REGISTRY OF RADIOACTIVE SEALED SOURCES AND DEVICES
SAFETY EVALUATION OF DEVICE

NO.: NR-313-D-101-S

DEVICE TYPE: Laser Target Designator/Ranger

MODEL: ~~117 Laser Designator~~ AN/AAS-38A LASER DESIGNATOR

ATTACHMENT 3

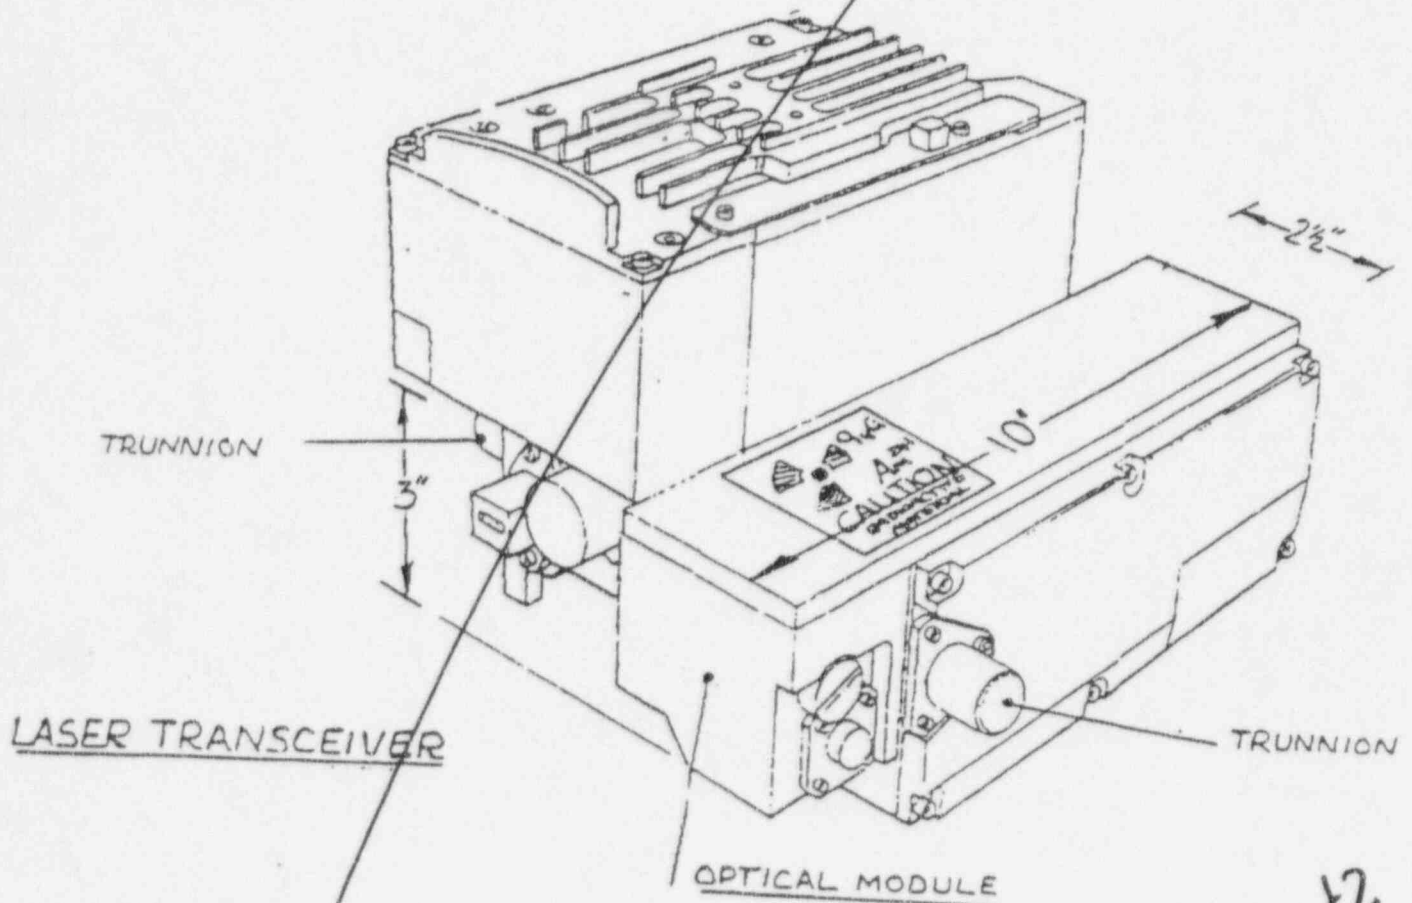
*Replace
BY FIGURES 1 & 2*

Figure No. 1 Laser Transceiver (Top View)

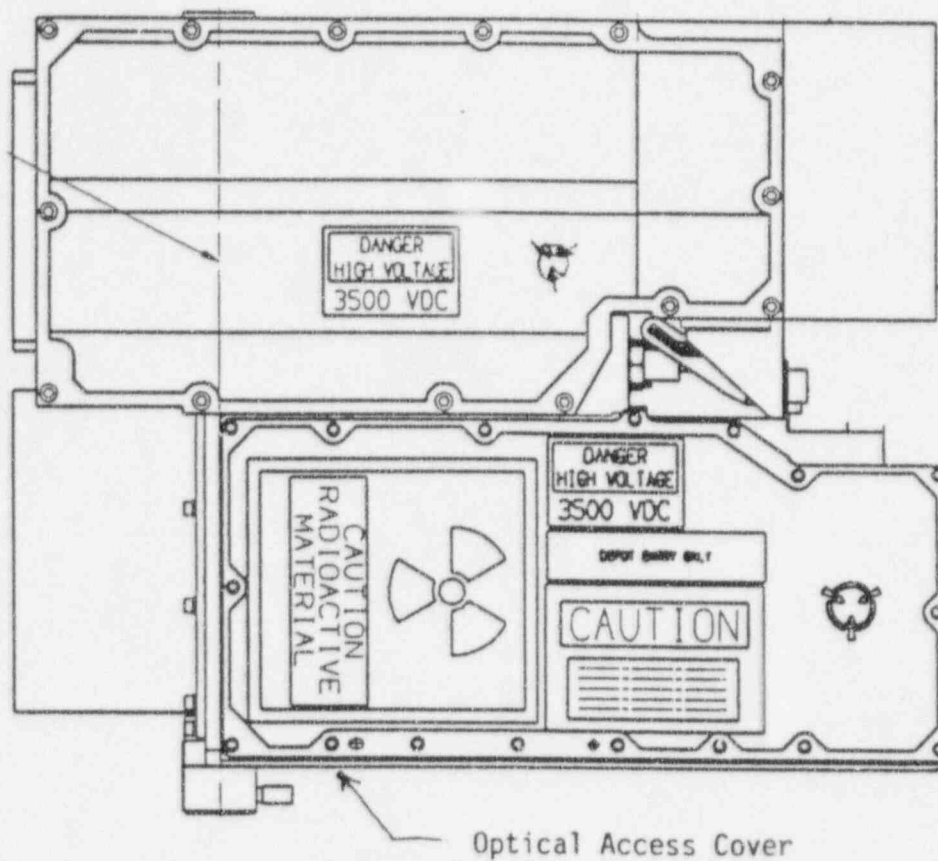
The device is contained in an environmental controlled cavity (AN/AAS-38A FLIR Pod). The device shown in Figure Nos. 1 and 2, contains two NRC-approved americium-241 (Am-241) sources (NR-136-S-~~174-1~~²⁰⁶), for the removal of static charge, one at each end of the laser's Q-Switch crystal permitting it to maintain its large characteristic discrimination ratio. The two sources are screwed and secured into the Optical Access Cover which is located on the laser transreceiver directly over the optics. The cover is an aircraft standard aluminum alloy machining, 7.5 inches long by 3.4 inches wide by 0.4 inches high, which mounts the sources. The optical elements of the laser are mounted within a sealed cavity directly below the cover. The cavity is approximately 1.7 inches deep and is also machined from aluminum. The sources are shown attached to the cover in Figure No. 5. The minimum thickness of the cover is .040 inches. The sources are placed approximately 1.5 inches apart and are threaded into the cover. An O-ring is placed between the chassis and cover. The cover is secured with seventeen screws and is opened only for depot maintenance. This prevents the ingress of moisture and the cavity is filled with dry nitrogen. Once assembled there is no ~~normal~~ access to the AM-241 sealed sources.

Figure No. 5. Sealed Source Assembly

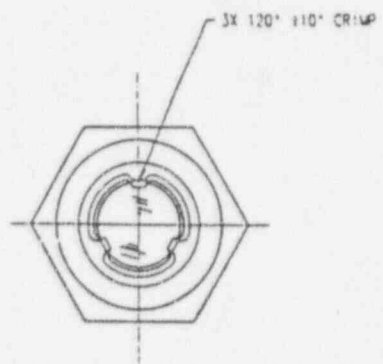
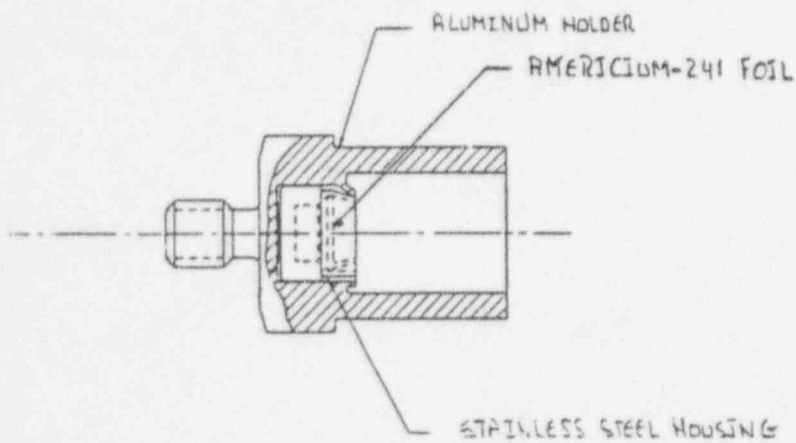
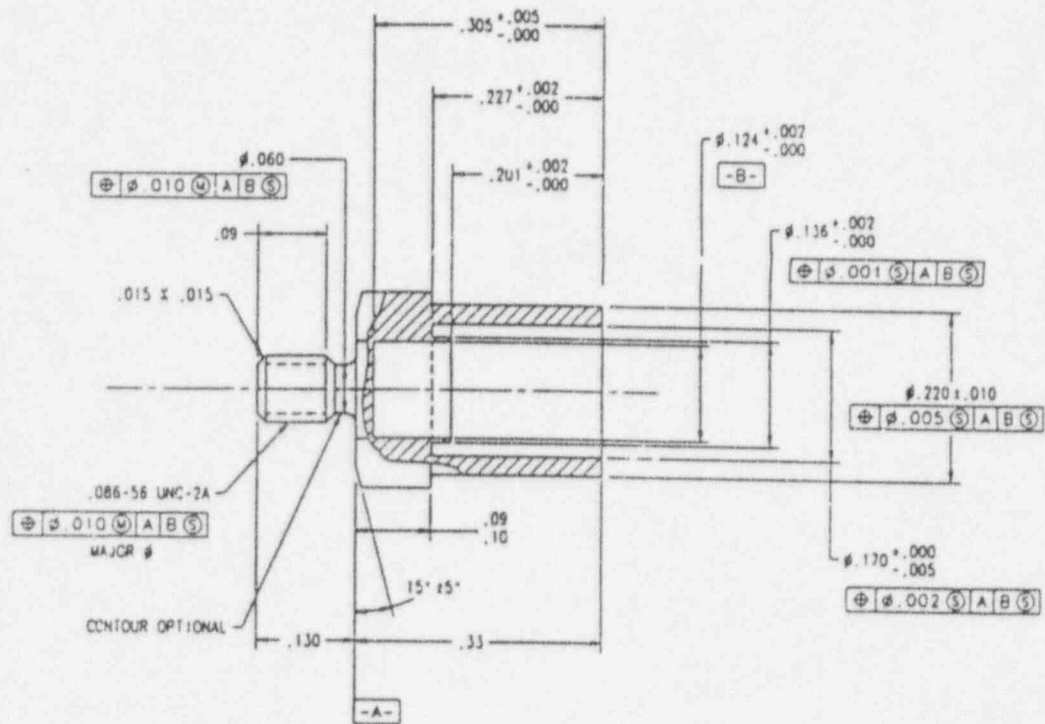
The AM-241 foil disk is crimped within a cylindrical stainless steel (304) housing. This sealed source is then placed in an aluminum holder and then secured within an aluminum threaded cylinder which is appropriately marked.
